# NORTH COAST RAIL TRAIL FINAL ENVIRONMENTAL IMPACT REPORT

## ADDENDUM

March 2020

This document is an addendum to the North Coast Rail Trail Final Environmental Impact Report (EIR) (SCH #2017092034, hereafter referred to as Final EIR).

Figure 3.4-3f Study Area Wetlands and Other Waters

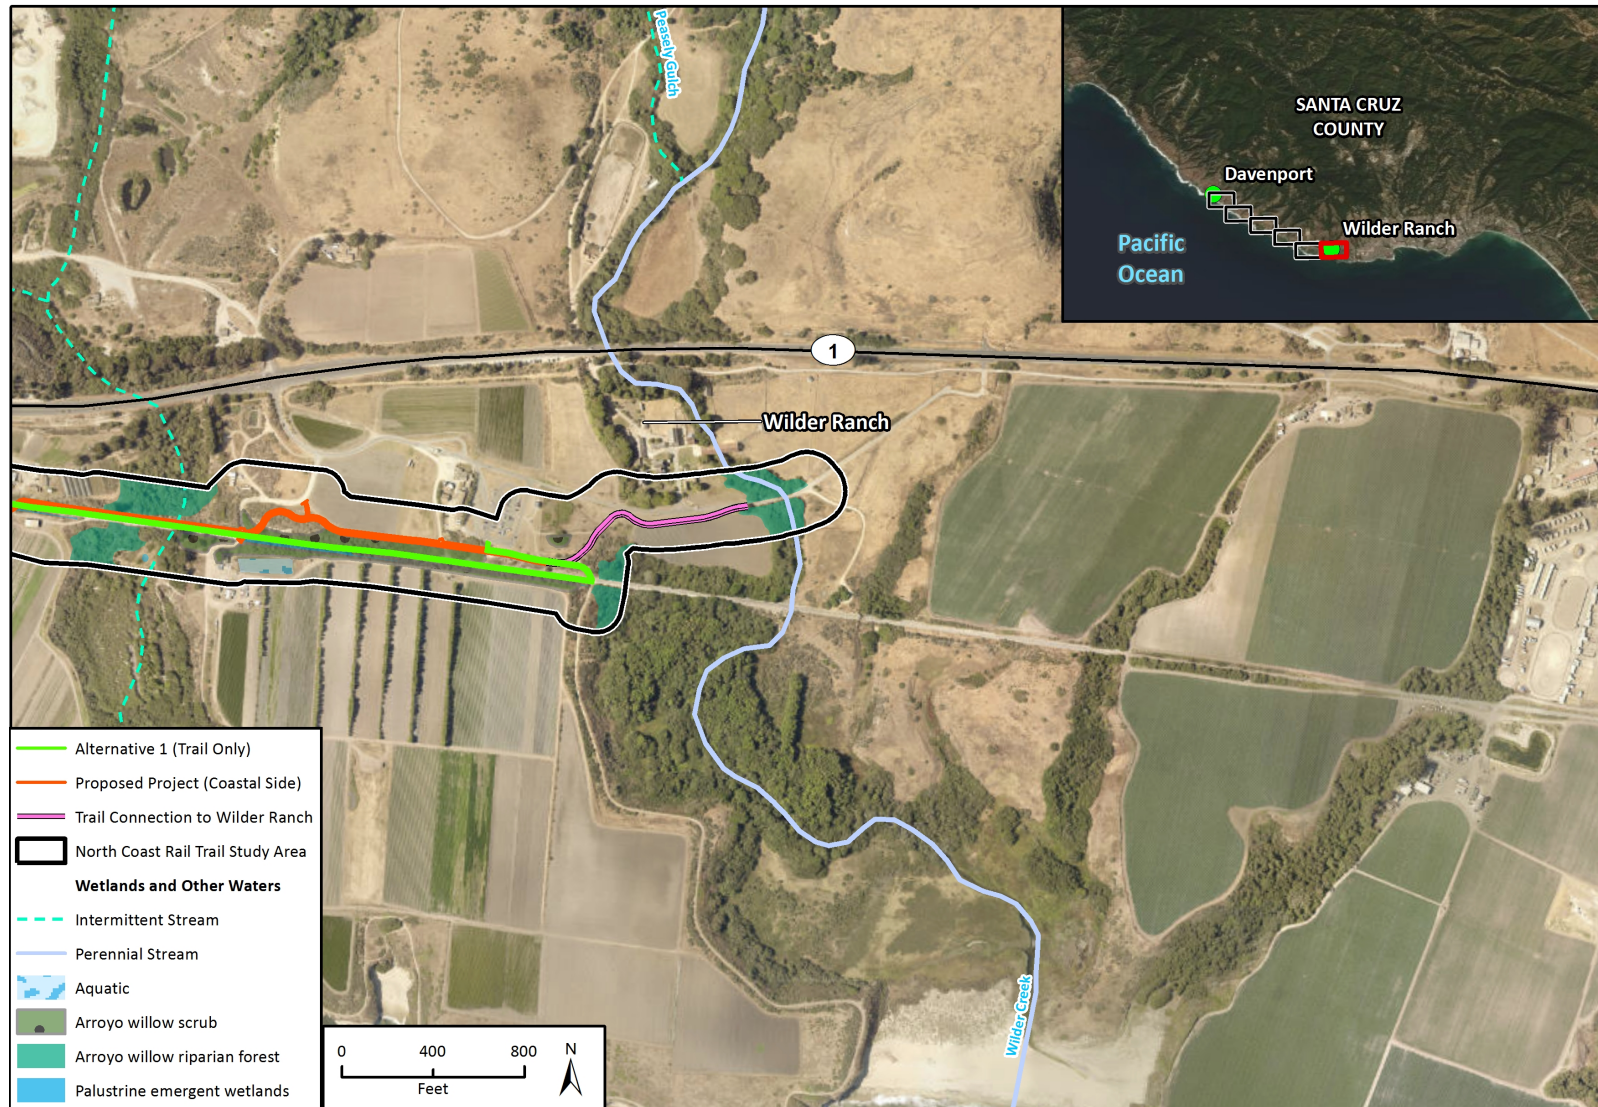
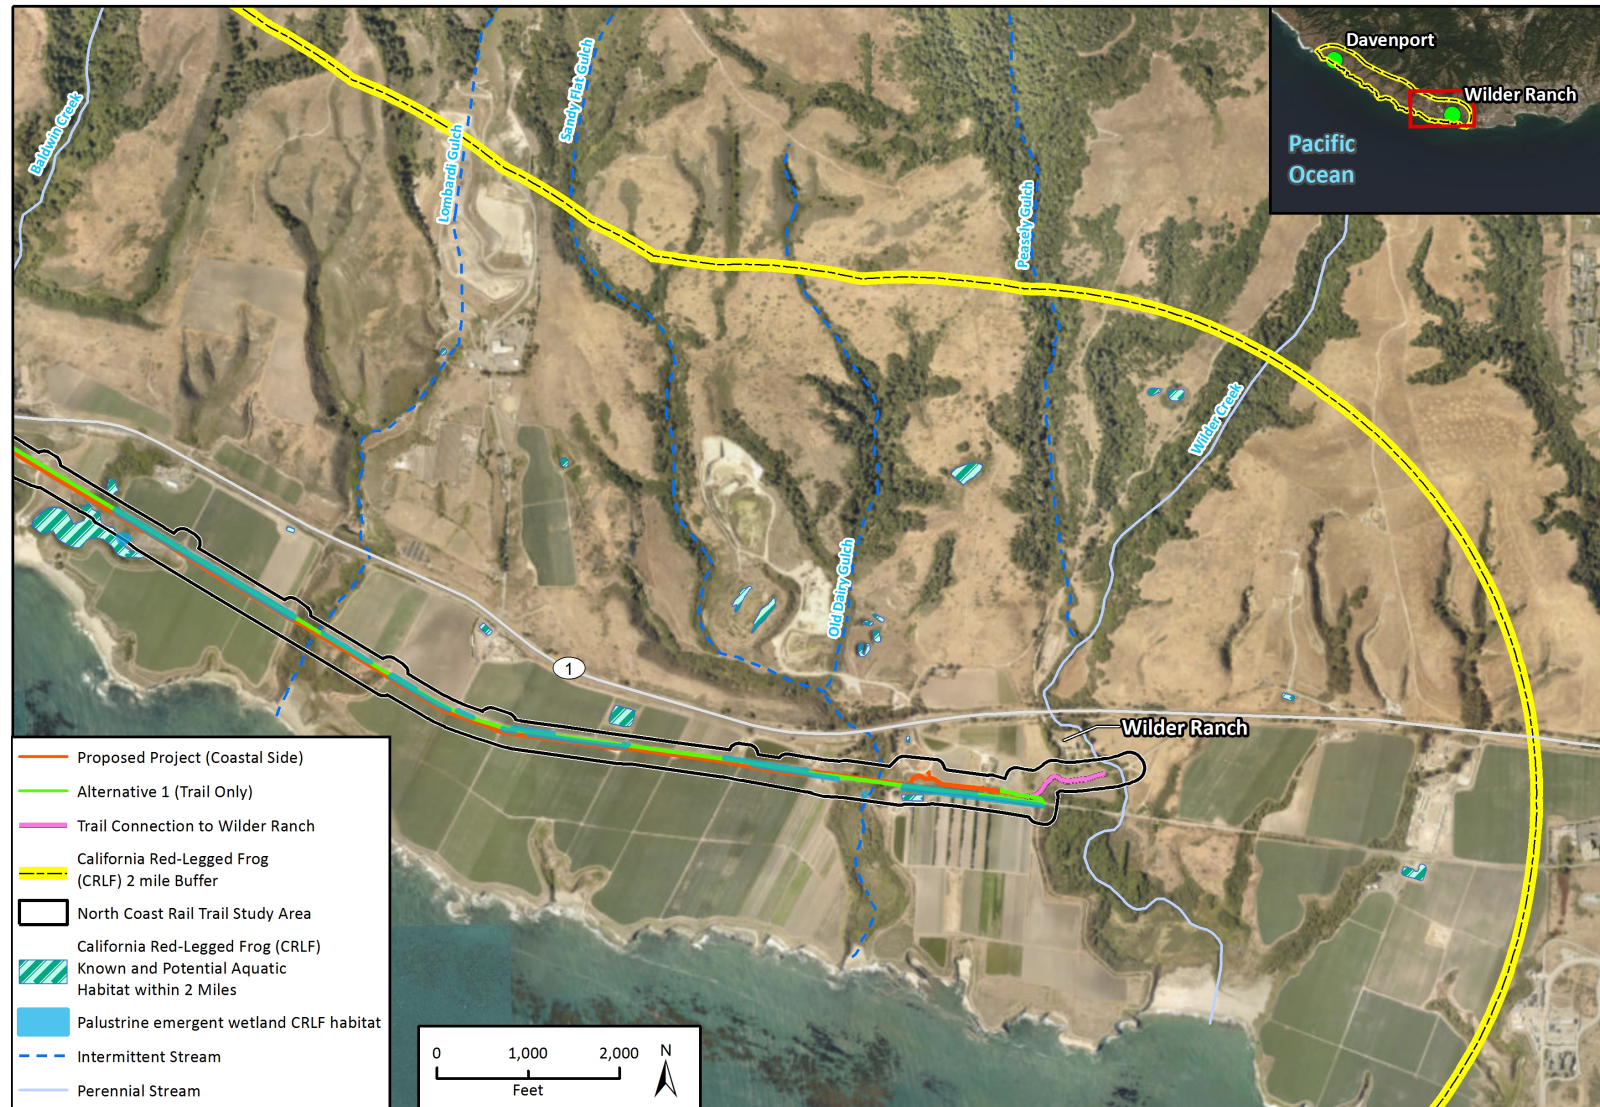
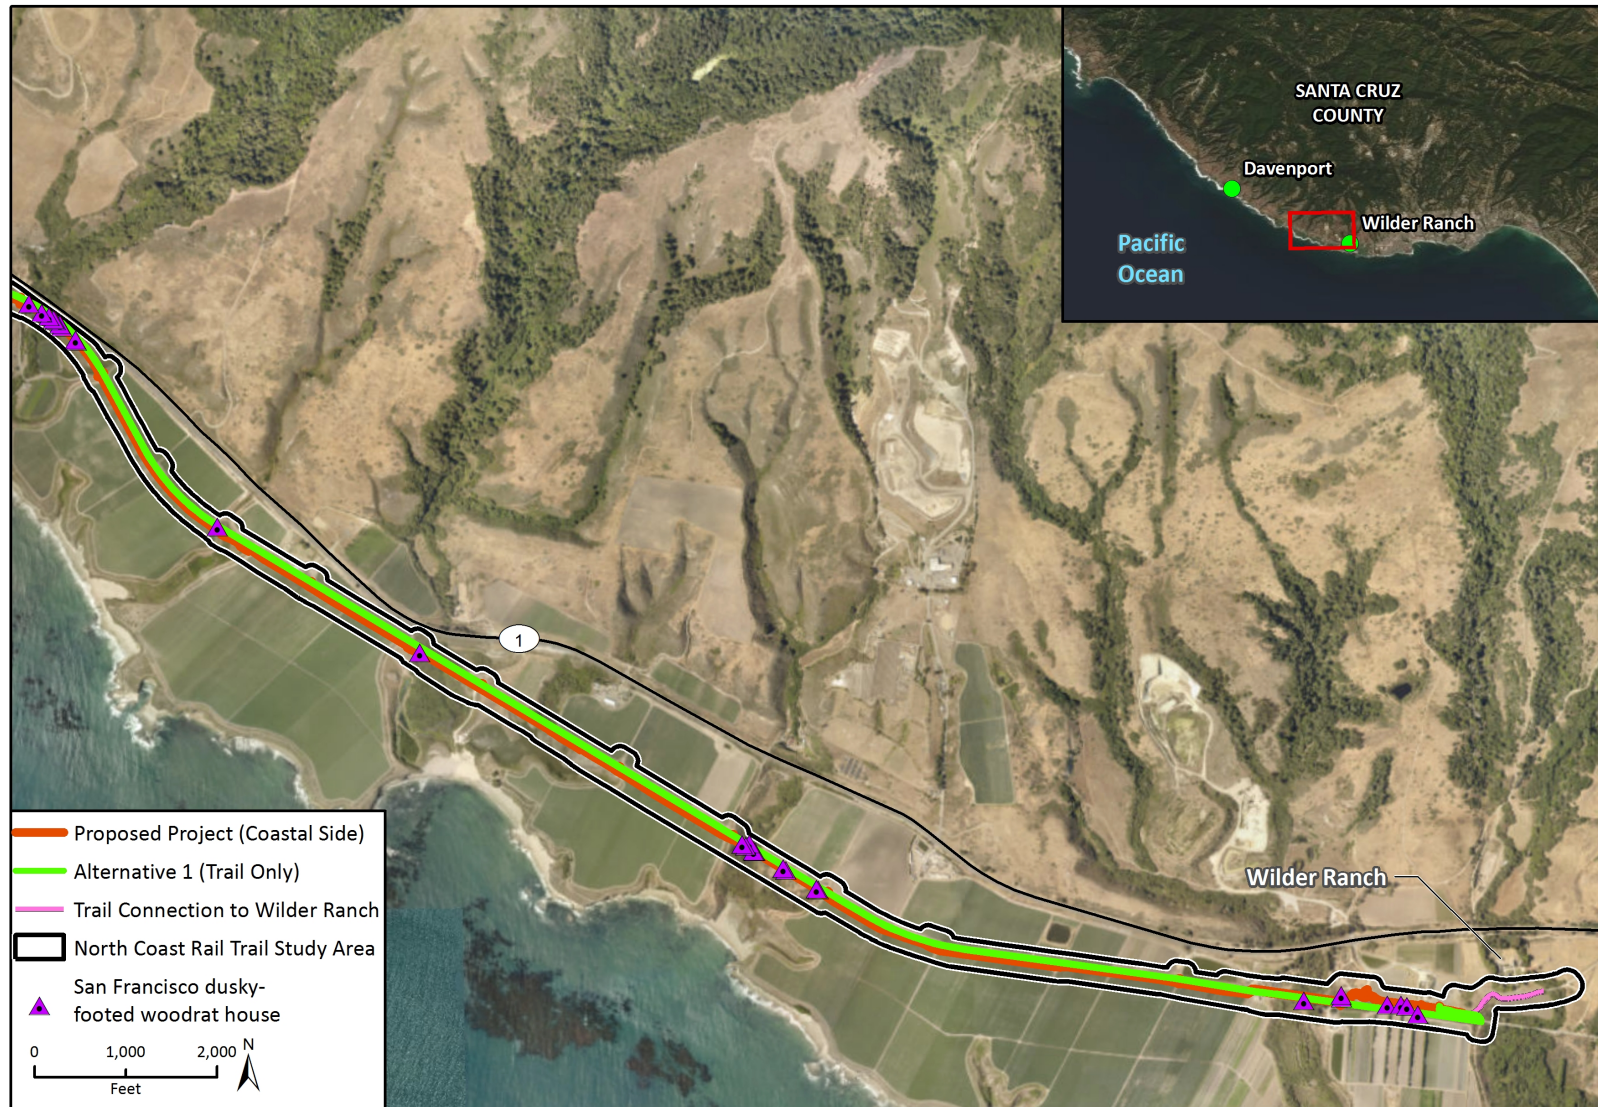
- n. Realign the portion of the trail extending through dune habitat near Bonny Doon parking lot, so it remains in the rail cut rather than above the rail cut on the coastal side (between Stations 86+00 and 90+00, as shown in Final EIR Appendix A.PP, Sheet 2 of 10, bottom). This would negate the requirement for Mitigation Measure BIO-8(b), Construct a Boardwalk in Coastal Dune Habitat. [Final EIR, Volume 2, Chapter 3.4 Biological Resources, Section 3.4.4, Project Impact Analysis, Impact BIO-8]

The trail realignment would keep the trail adjacent to the rail for an additional 175 feet, crossing through the existing sand dune that has begun to form on and adjacent to the railbed due to lack of maintenance, before beginning to climb up on to the bluff through ruderal and coastal scrub habitat located immediately southeast of Bonny Doon Beach (refer to Appendix A.PP, approximately station 90+00). An approximately 8-foot-high, 125-foot-long rockery retaining wall using native materials would be constructed on the coastal side of the trail (refer to Appendix A.PP, from approximately station 88+25 to 89+50). The retaining wall would be positioned below the bluff to eliminate the need to cut and lay back the sandy slope, thereby reducing the project footprint to accommodate the trail.

Changes to the trail alignment in Wilder Ranch would not impact sensitive habitats or special status species. The previous alignment was located on an existing paved road covering approximately 0.23 acres. The revised alignment is located on the coast side of this road and now affects 0.08 acres of developed, 0.06 acres of agriculture, and 0.09 acres of non-native grassland habitats within the footprint of the realigned Wilder Ranch trail segment. These habitats are not classified as sensitive and are highly degraded due to repeated and ongoing
